SEWAGE DISPOSAL SYSTEM

MARYLAND STATE DEPARTMENT OF HEALTH

SUBDIVISION Patapsco Park Estates

LOT New Lot 21
(Old Lot 6)

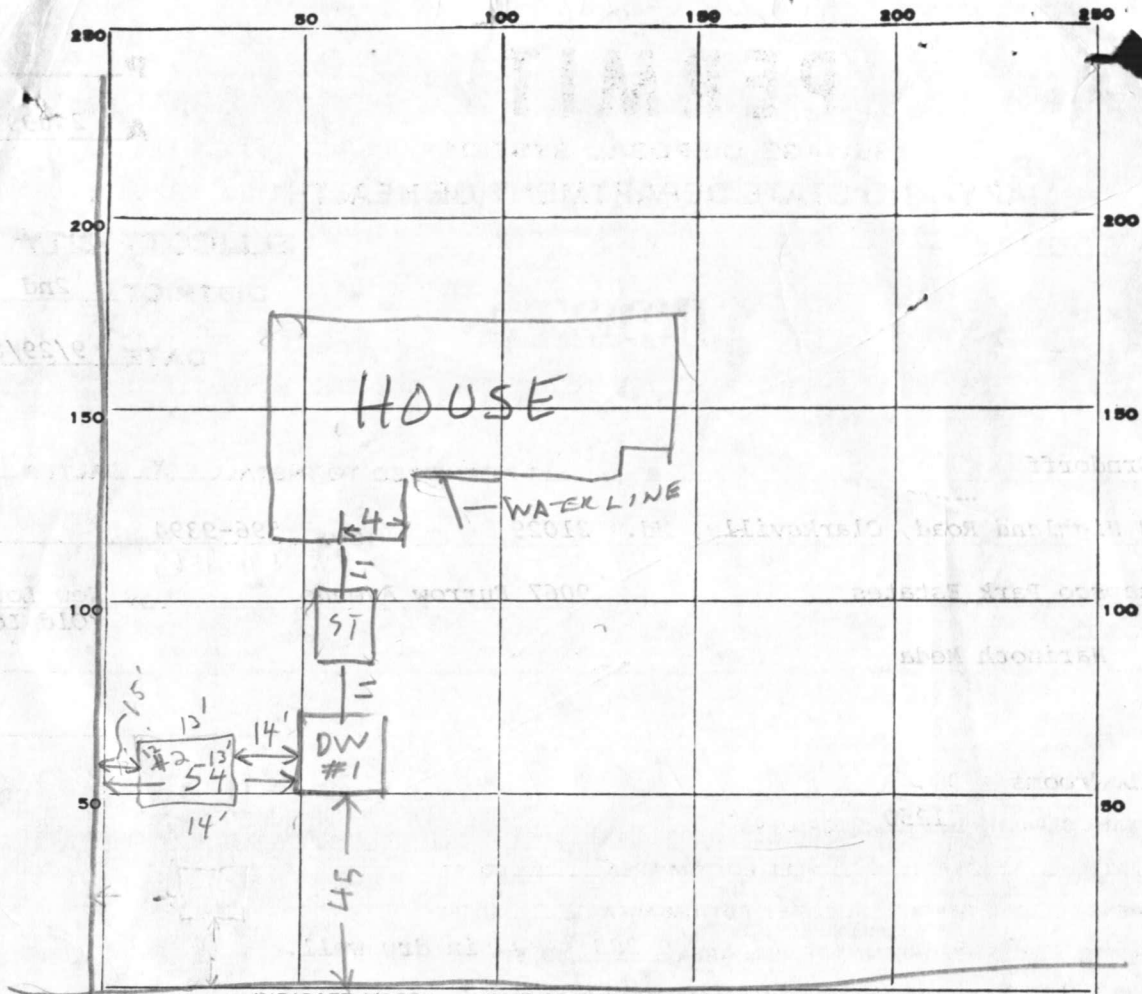
10/8/80 - OK TO USE 2 DW INSTEAD

OFA DW & DITCH. 1ST DW IS INSTALLED ALREADY ACCORDING TO

ORIGINAL SPECS & HAS 366 SQFT. 2ND DW TO HAVE 250 SQFT

PLACE THE 2ND DW 20 FT

FROM THE FIRST DW

TOWARD THE LEFT SIDE OF THE LOT

AS SEEN WHEN FACING THE LOT

FROM FURROW AVE

HD - 23 USE CAST IRON PIPE TO CONNECT THE

TWO DRY WELLS

REMARKS 8 OCT 80 - DW #1 INLET 4 FT BELOW GRADE OK TO COVER

TANK & FIRST DW. CALL FOR INSPECTION OF 2ND DW.

10/10/80 CHECKED #2 DRYWELL IN PER REVISED SPECS. C.R.S.
